ALTOONA CITY PLANNING COMMISSION

Regular Meeting of Tuesday, August 5, 2025 at 3:00 PM
4th Floor City Hall Common Room

**RE: FINAL LAND DEVELOPMENT PLAN - PARKING IMPROVEMENTS
901 VALLEY VIEW BLVD. LLC / ALTOONA CENTER FOR ORAL AND MAXILLOFACIAL
SURGERY
CITY OF ALTOONA, BLAIR COUNTY**

PROPOSED LOT LINE RELOCATION AND FINAL DEVELOPMENT PLAN

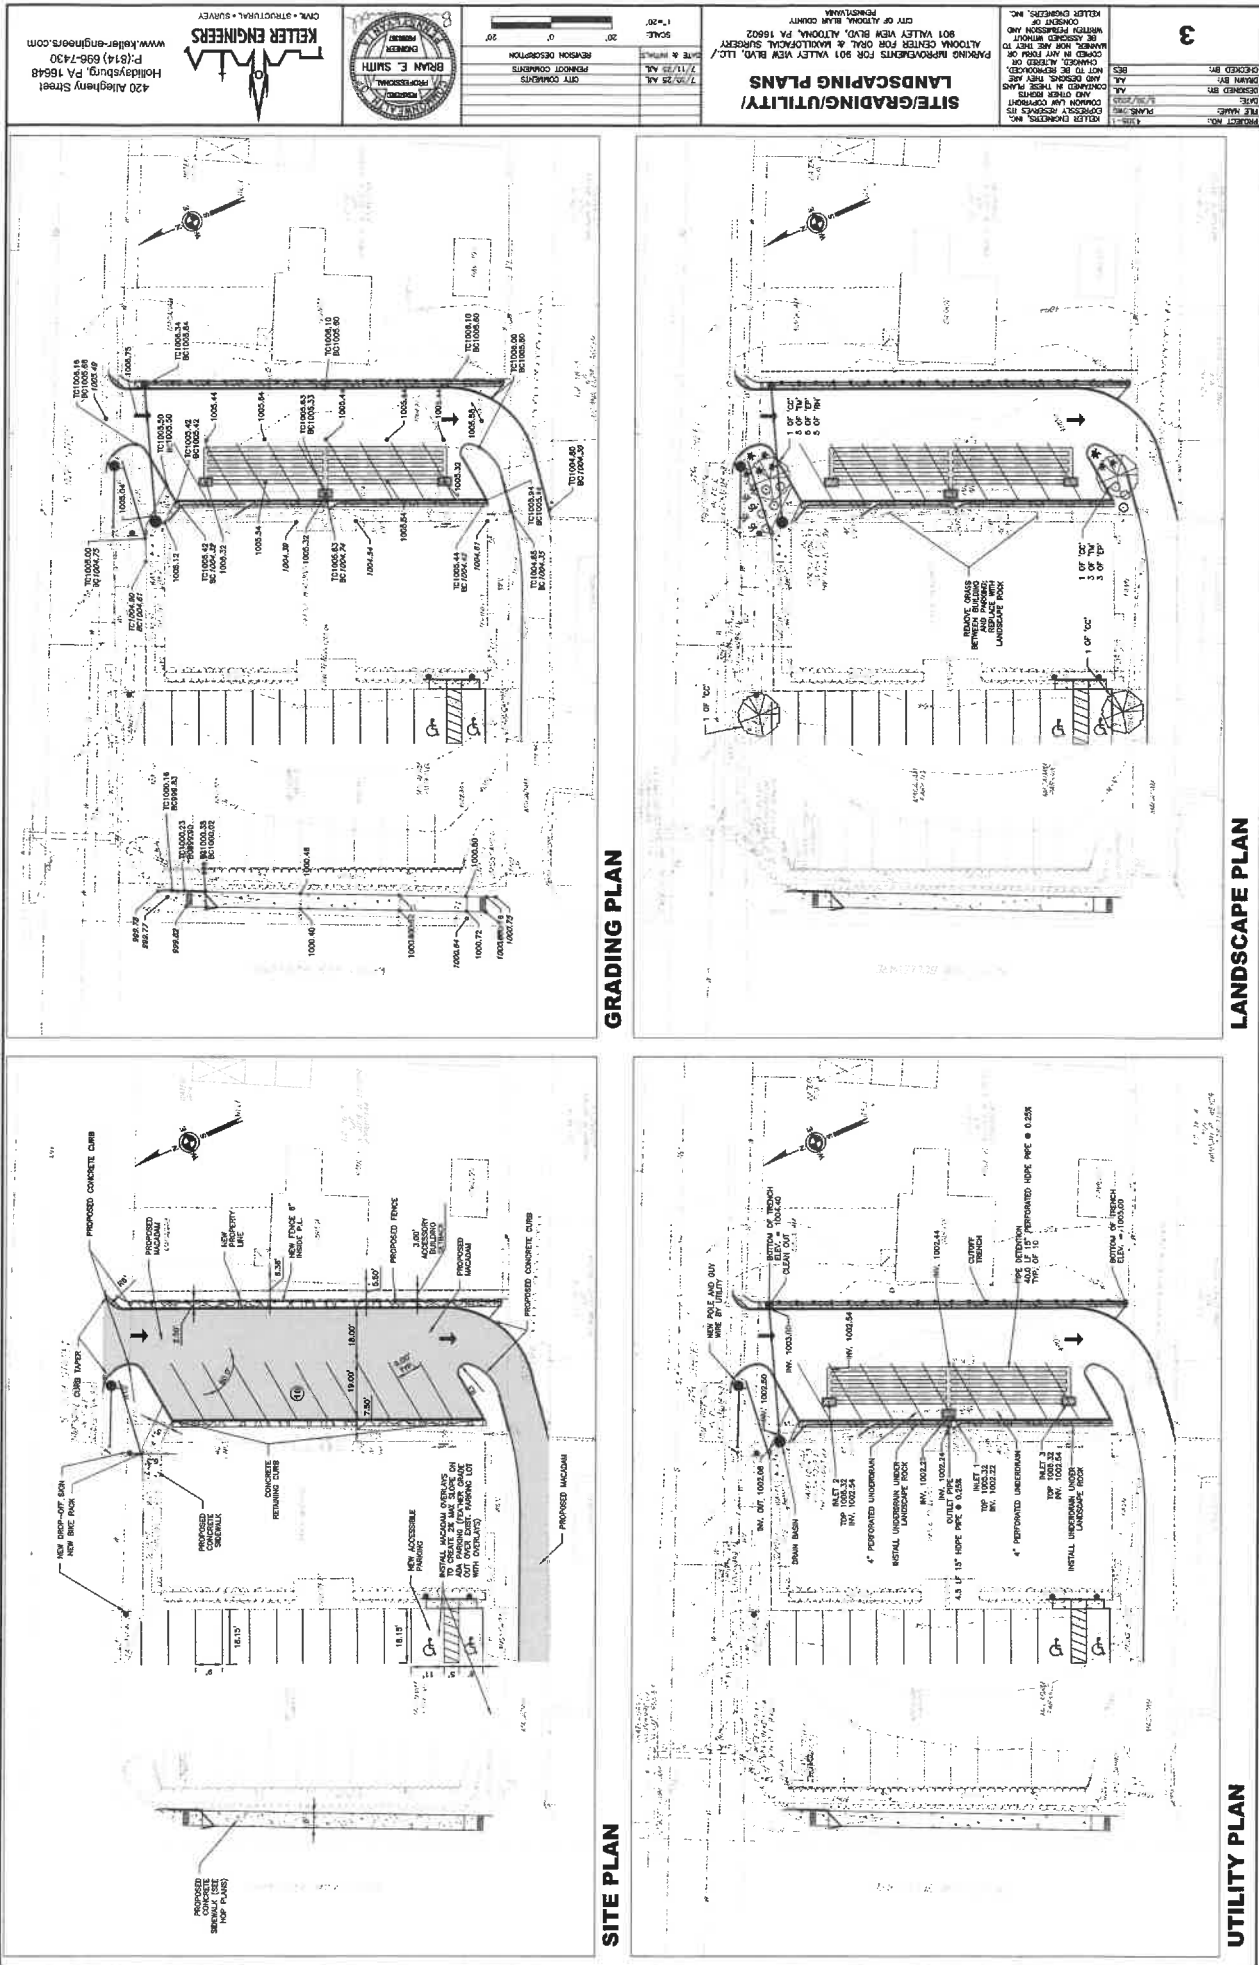
1. This review notes that the preliminary/final lot line relocation plan depicts existing building and building setbacks measured from the proposed lot lines. After the line moves, every existing building on the project site will be non-conforming relative to the current setback requirements. The only existing structure that currently meets setback requirements is one of three outbuildings on the Stoehr parcel.

- d. This review did not identify any other potential issues of concern with the lot line relocation plan.
2. The Final Development Plan shows the location of the existing surgery center building, current parking configuration on the west side of the building, proposed parking on the east side of the building, and other proposed features.

- f. The final development plan proposes a 6' high fence along the inside of the new property line (Sheet 3, site plan detail). The project narrative explains that an “opaque fence is being installed along the property line since there is no room for a vegetative buffer.” This explanation and site design may be an alternative to the side yard requirement in Section 800-47(Q).

- i. This review did not identify any other potential issues of concern with the final development plan.
- 3. PennDOT will require a new or revised Highway Occupancy Permit (HOP) for the proposed sidewalk in the SR 1001 right-of-way (plans provided on Sheet HOP1). PennDOT may also consider the proposed additional traffic using the alley access to SR 1001 during its review of the HOP application.
